SUBJECT: Proposed New Sentinel Monitoring Well Approval, Groundwater Monitoring Program  
for the Ripon HWY FF/NN Landfill  
Ripon HWY FF/NN Landfill  
License #467, Ripon, WI  
**WDNR BRRTS #02-20-000915**

RE: New Monitoring Well Installation  
Ripon HWY FF/NN Landfill  
License #467, Ripon, WI  
BRRTS #02-20-000915

FF/NN LANDFILL RIPON, WISCONSIN	DATE: 3/9/16
<b>MONITORING LOCATION MAP</b>	DESIGNED: HJW
	CHECKED: MRN
	APPROVED: MRN
	DRAWN: HJW
	PROJ.: 117-220254
 <b>TETRA TECH</b>	Figure 1

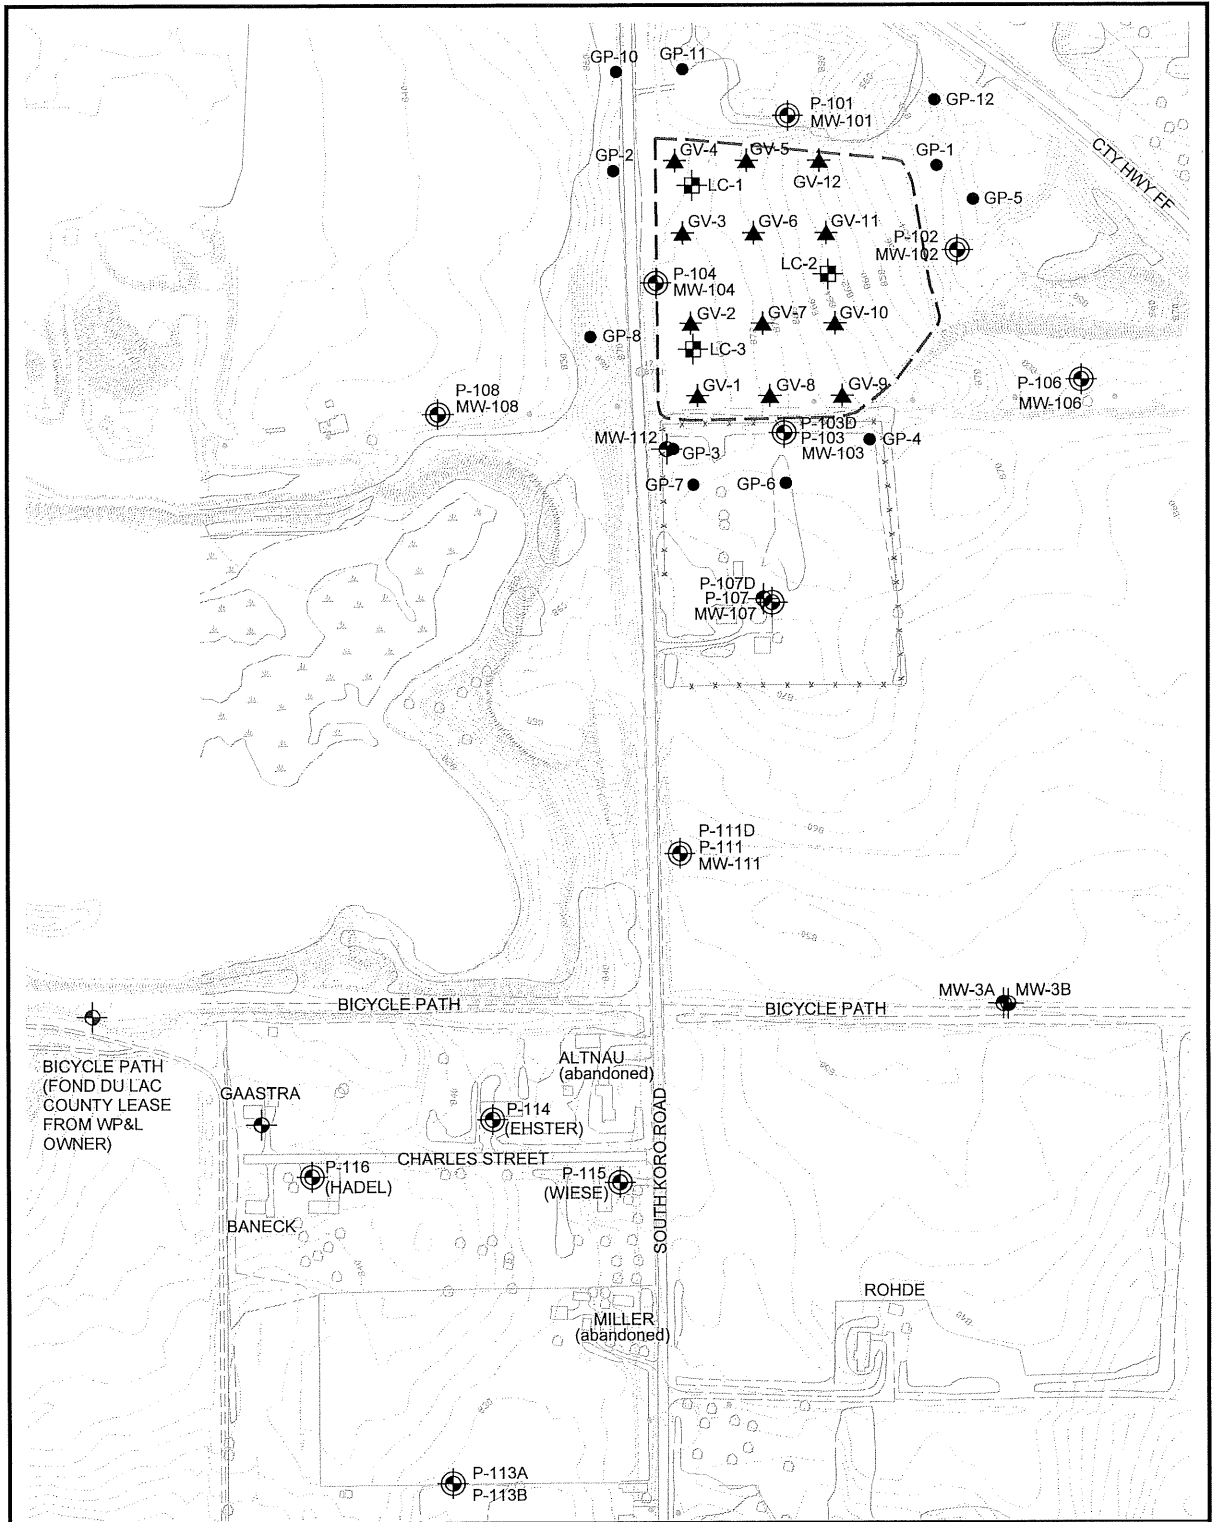
Mike, eyeballing the map, it appears the location shown in red for the well location is less than 300 feet from the property line. Is that the exact location proposed or approximate? Will a more accurate location be provided later once we approve and you obtain access?

Gary, the proposed location is 300 feet west of the property line (see attached). The exact location will depend on site access.
